Service Manual

Video Product

Subject: Improvement of Performance
(Installation of VMD2063KIT and VXA5036KIT)

Model No. :	LX-900U/CA	VRD9208M129
	LX-900EN	VRD9208M131
	LX-K700U/CA	VRD9207M127
	LX-K700EN	VRD9207M128
	LD700	VRD9208M130

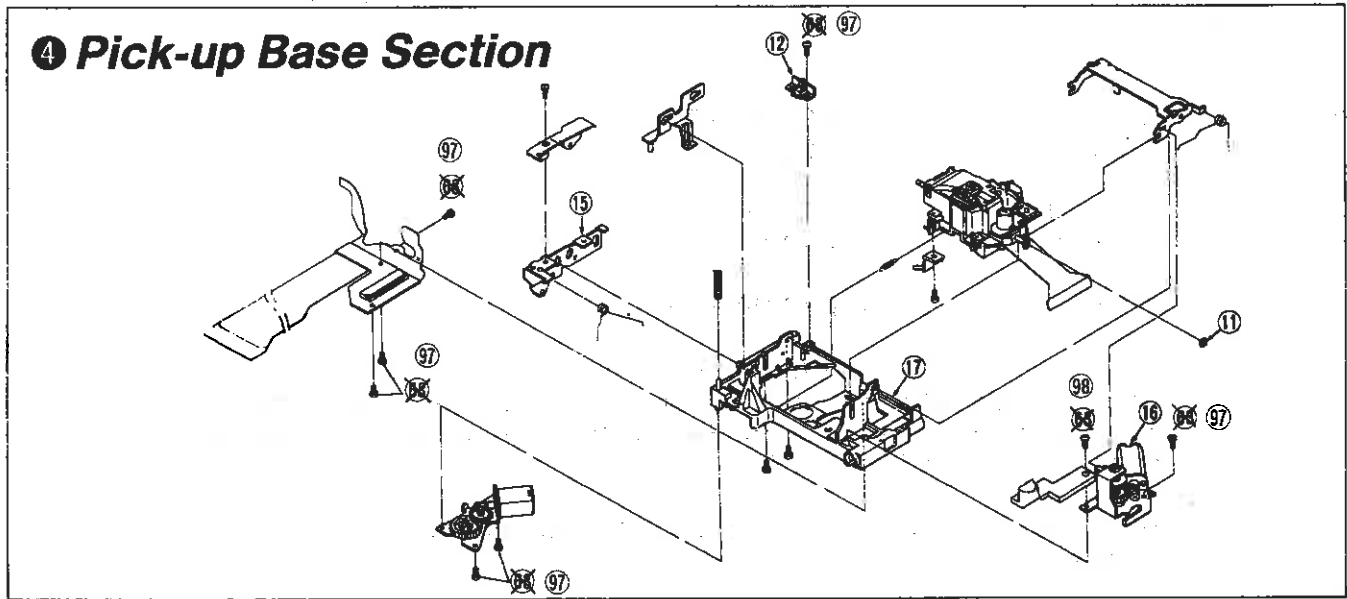
The all of the Pick-up Base for Auto Reverse Type (mentioned above) use Aluminum Die-cast. However, it has been changed to Epoxy Polyethylene beginning with '93 model, LX-600.

Due to change it, the following parts have been changed.

Since these Kits are installed following parts, please refer to the following method before replacing the Pick-up Base and Roller Base (A).

When changing the Pick-up Base to Epoxy Polyethylene from Aluminum Die-Cast, change the following parts at the same time. Then, remove the PU Spacer (11).

Because there are two types of Roller Base (A) when changing it, since the hole size in the Roller Base (A) is different between Aluminum Die-Cast and Epoxy Polyethylene, Roller Base (A) may not align with the Pick-up Base.

In this case, change the included Roller Base (A).

- For Aluminum Die-Cast : Hole Size Small
- For Epoxy Polyethylene : Hole Size Big

Parts No.	Installation Parts
VMD2063KIT	(15) Roller Base(A) (VXA5036) (16) Height Base (VXA4041) (17) Pick-up Base (VMD2063) (97) Screw x 7 (XQN2+CJ5) (98) Screw x 1 (XQN2+CJ7)

Parts No.	Installation Parts
VXA5036KIT	(15) Roller Base(A) OLD : (VXA4039), NEW : (VXA5036)

(Page 3-30, B-6)

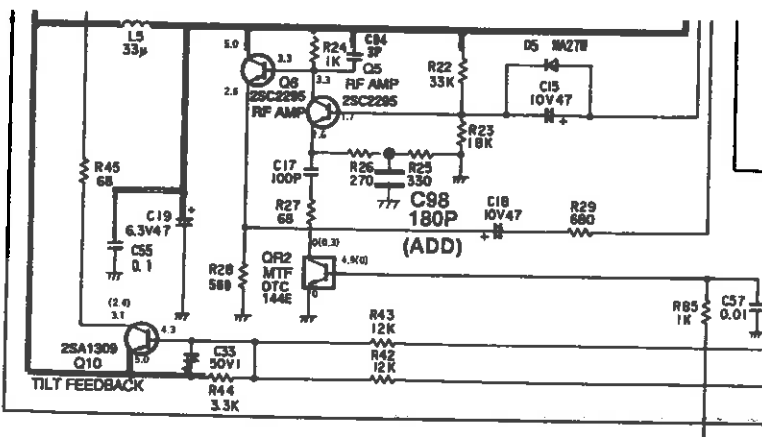
Subject: *Addition of A Capacitor for CAV Disc Search Operation (Servo Circuit)*

The following parts has been changed.

Ref No.	Original Parts No.	New Part No.	Parts Name & Descriptions	I/C	Remarks
C22098	—	ECUM1H181JCN	C. CAPACITOR CH 50V 180P	E
